LINCOLN/LANCASTER COUNTY PLANNING STAFF REPORT

for November 23, 2005 PLANNING COMMISSION MEETING

PROJECT #: Change of Zone No.05077
Thunderstone Planned Unit Development (PUD)

PROPOSAL: From H-3 to H-3 PUD for 36,000 square feet commercial/industrial floor area and a 9,000 square feet warehouse.

THUNDERSTONE P.U.D.

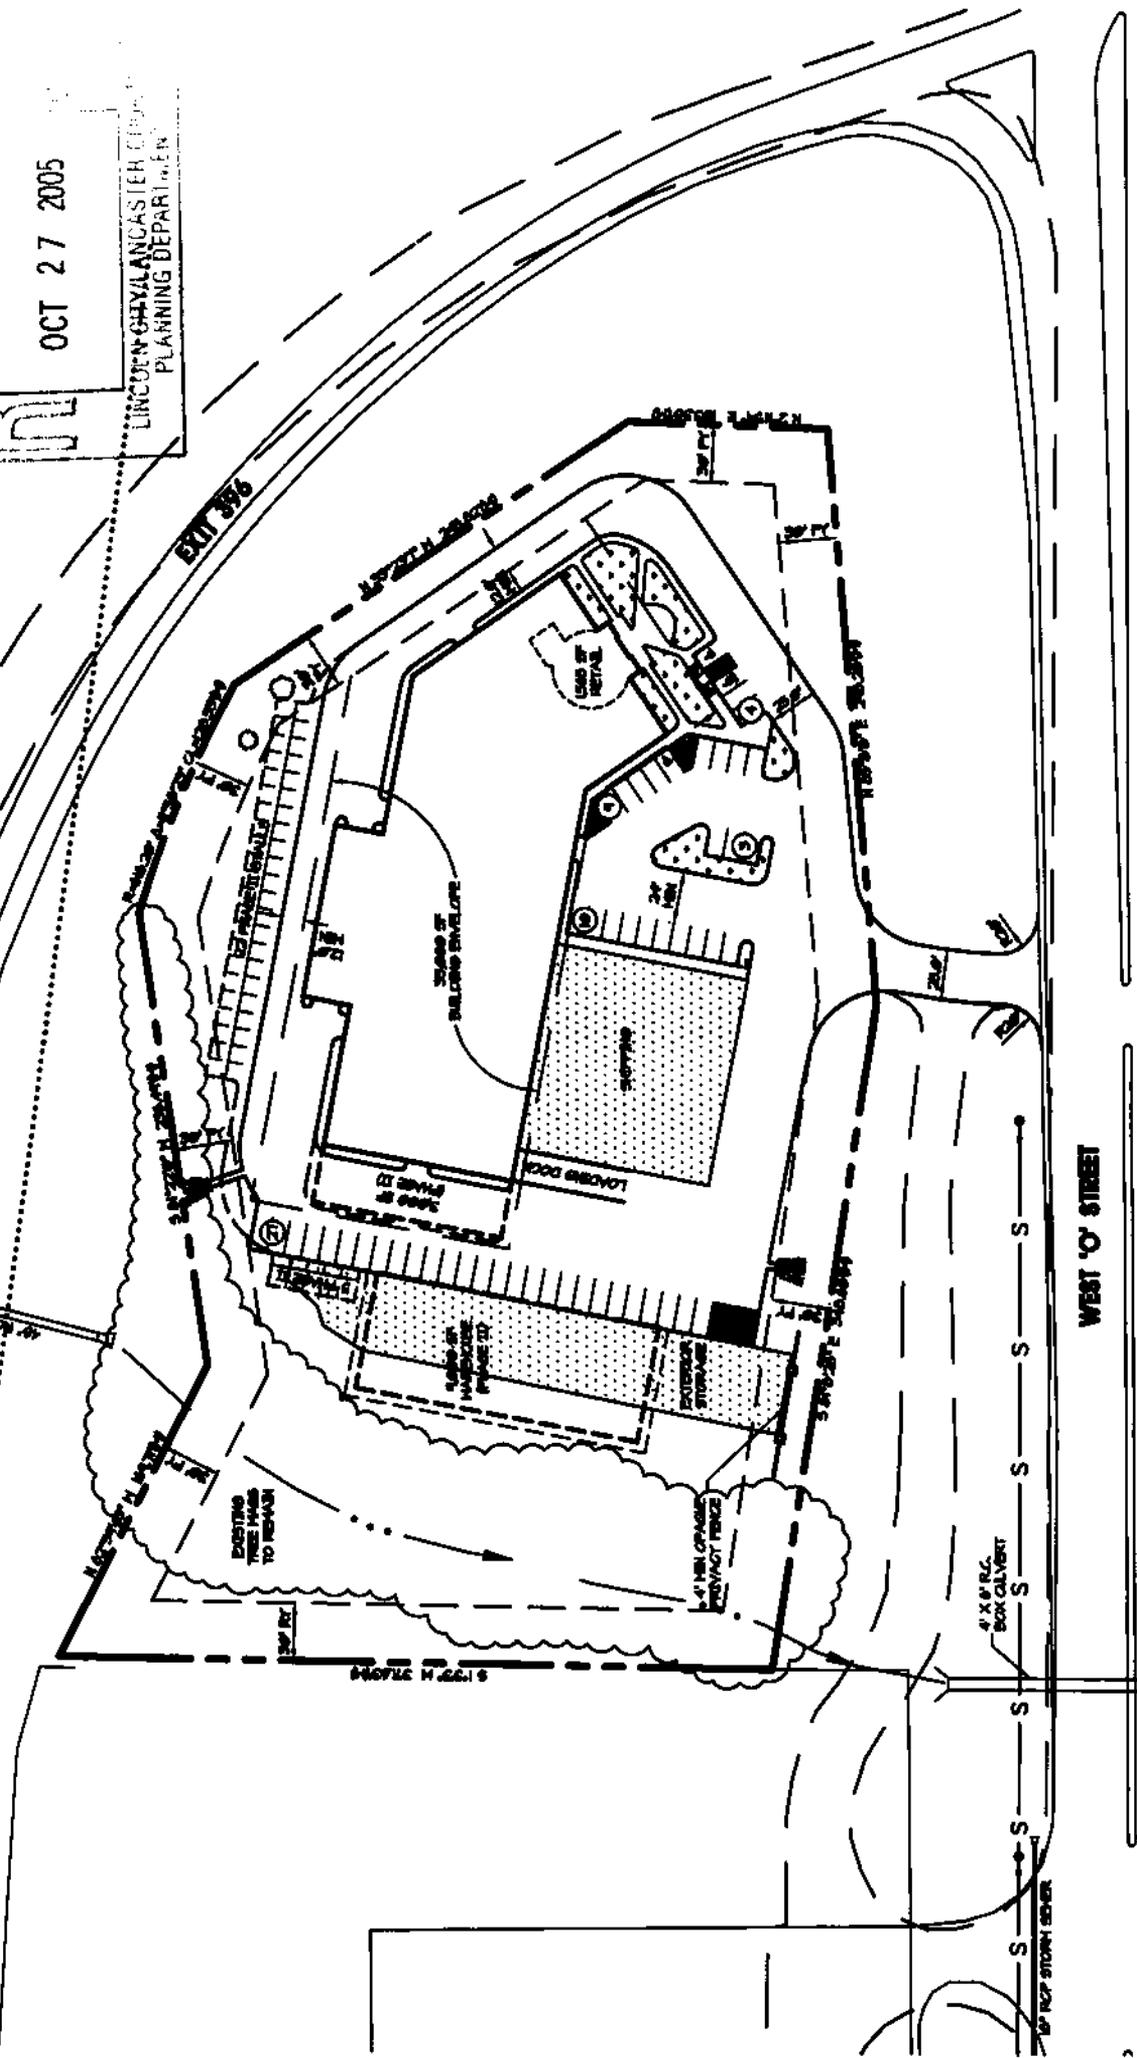
1.1 Revise the site plan to show:

- 1.1.1 Delete Note 10 from the general notes.
- 1.1.2 Define the dot pattern and the cross hatch. Add it to the legend.
- 1.1.3 Delete the note about a median opening and show a full median On West "O" St. across from the entrance.

- 1.1.4 Remove the exterior storage from the front yard setback.
- 1.1.5 The landscape area east of the entrance must be a minimum of six feet between the lot line and the drive.

- 1.1.6 The west boundary of the site is a side yard and requires only a 15' setback.
- 1.1.7 Show minimum flood corridor for channel on the western portion of the site.

- 1.1.8 Make revisions to the satisfaction of Public Works and Utilities memo of November 8, 2005.
- 1.1.9 Show a 10' utility easement on the north, west and east lot line and a 15' utility easement on the south lot line per LES memo of November 3, 2005.

- 1.1.10 Show 10 street trees along West "O" St. The street trees must be on private property.
- 1.1.11 Delete the "1,565 s.f. retail" note from the plan.

- 1.1.12 Delete the specific stall count in the parking table. Replace the stall count with a note stating that parking for retail shall be at 1 stall per

200 s.f. and parking for manufacturing/warehouse shall be at 1 stall per
1,000 s.f. in conformance with the H-3 district.

1. Watershed Management does not agree to the requested waiver of storm water detention standards. Provide calculations for required detention as per Drainage Criteria Manual Chapter 6 or provide calculations demonstrating why detention should not be required.
2. Show minimum flood corridor for channel on the western portion of the site as required per Lincoln Municipal Code 26.15.020 (9).

(1.1) Additional information needs to be provided showing that the proposed sanitary sewer extension will work in regard to the existing box culvert and any proposed drainage structures designed with the State's West O Street widening project.

(1.2) General note #10 refers to the use of tax increment financing or assessment districts to pay public utility extensions. The PUD does not approve the funding source for site improvements and any reference to TIF or assessment districts should be removed from the site plan.

(3.1) The storm drainage outlet at the northwest corner of the site should be relocated to the west so as to not require any construction and adverse effects in the state ROW.

(3.2) Public Works does not approve the requested waiver of design standards for detention. The application letter indicates that insignificant impact will result in waiving detention. However, no supporting information has been provided. Information needs to be provided justifying the waiver of detention.

(4.1) The note on the site plan indicating the enlarging of the existing median opening needs to be removed from the plans. The full access movement for this site will be provided by the wider

opening to the west of this site. Public Works does not approve the full access connection to this site until the proposed access road is constructed. If the full access is granted, adequate left turn storage needs to be provided and any improvements in West O Street that are required should be the responsibility of this developer.

(4.2) A 200' long right turn lane needs to be shown for the proposed drive and it should be the responsibility of this developer.

(4.3) The future West O Street widening and associated grades need to be shown on these plans. This site will need to accommodate the widening and grading.
